UNITED STATES PATENT AND TRADEMARK OFFICE

10/578,339

Office Action Summary	Application No. 10/578,339	Applicant(s) STROHMAIER ET AL.	
	Examiner GURPREET KAUR	Art Unit 1795

DETAILED ACTION

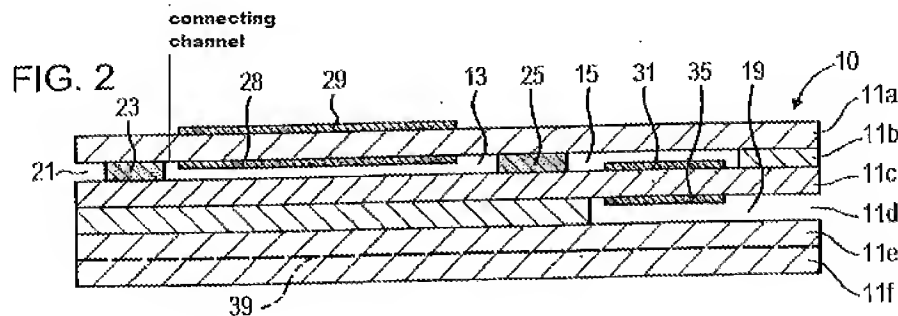
Regarding claim 34, Stahl teaches a Nernst cell (measurement space, 15) made up of electrolyte (11b) and two electrodes (31 and 35), 31 is inside the measurement space, 15 and 35 is exposed to pump air in a reference channel, 19 (see figure 2);

a pump cell (measurement gas space 13) with the pump electrodes (electrodes 28 and 29) for pumping the oxygen. Electrode, 28 is inside the compartment, 13 and electrode, 29 is outside and exposed to gas mixture (see figure 2). Stahl teaches that inner electrodes (28 and 31) can be combined to form a continuous electrode (see col. 4, ll. 14-16), therefore it would obvious to one of ordinary skill in the art to assert from the teaching of Stahl combined inner electrodes as one electrode is present in the measuring chamber

a connecting channel (see annotated figure 2 below) to exhaust port, 21 which opens to measuring chamber (15), the diffusion path (gas intake port, 21 which is equivalent to channel) is part of the storage volume (measuring gas compartment, 13) and diffusion barrier (25) is situated between the measuring chamber (15) and storage volume (see figure 2).
